Symbol: EPC-DO: 24-049

Subject: DP-1132, Condition Number 2, Notification of Changes, Radioactive Liquid Waste Collection System Modification, Technical Area 3 Structure 16

Radioactive Liquid Waste Collection System Modification - TA-3-16 Map

Radioactive Liquid Waste (RLW) Collection System Modification - TA-3-16

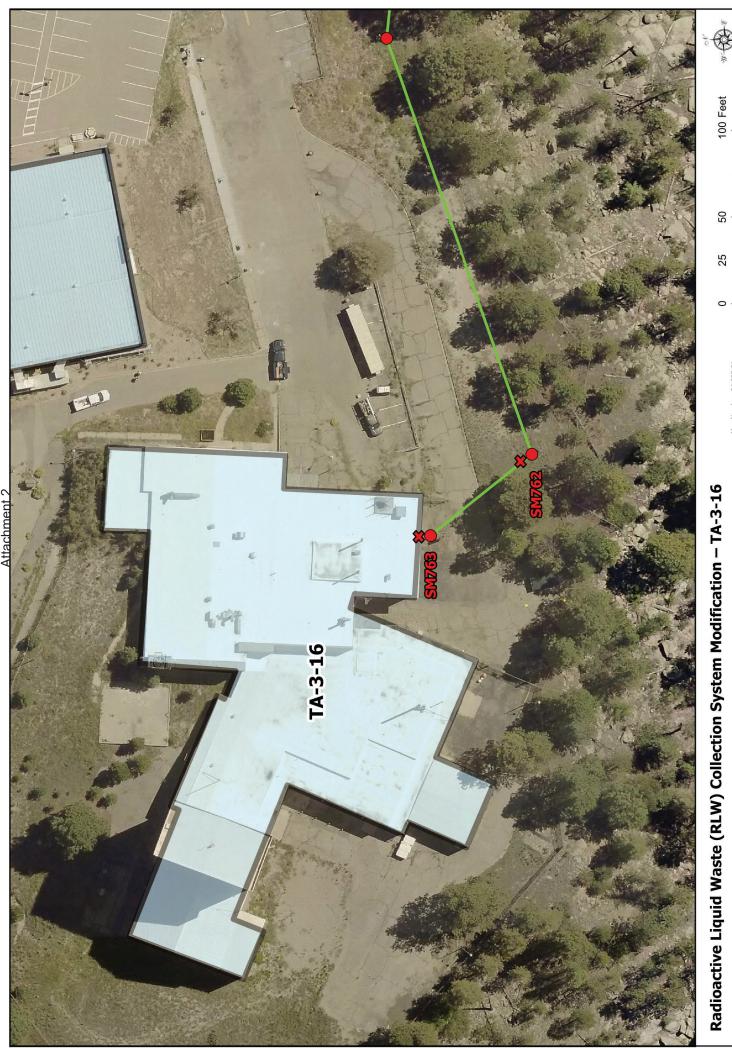
- The RLWCS pipe from TA-3-16 will be cut and capped between TA-3-16 and RLWCS Vault SM763
- The RLWCS pipe upgradient of RLWCS Vault SM762 will be cut and capped. The section of pipe from this cut extending downgradient into Vault SM762 will be removed.
- The opening in SM762, where the piping will be removed, will be sealed to prevent intrusion of stormwater into the vault.

- d. Units or components being removed from the process: After the RLWCS modifications are completed:
 - The existing RLWCS line will be cut and capped in two locations: i) between TA-3-16 and RLWCS Vault SM763 and ii) upgradient of RLWCS Vault SM762.

- The section of pipe from the cut upgradient of RLWCS Vault SM762 extending downgradient into Vault SM762 will be removed.
 - RLWCS Vault SM763 will be taken out of service.
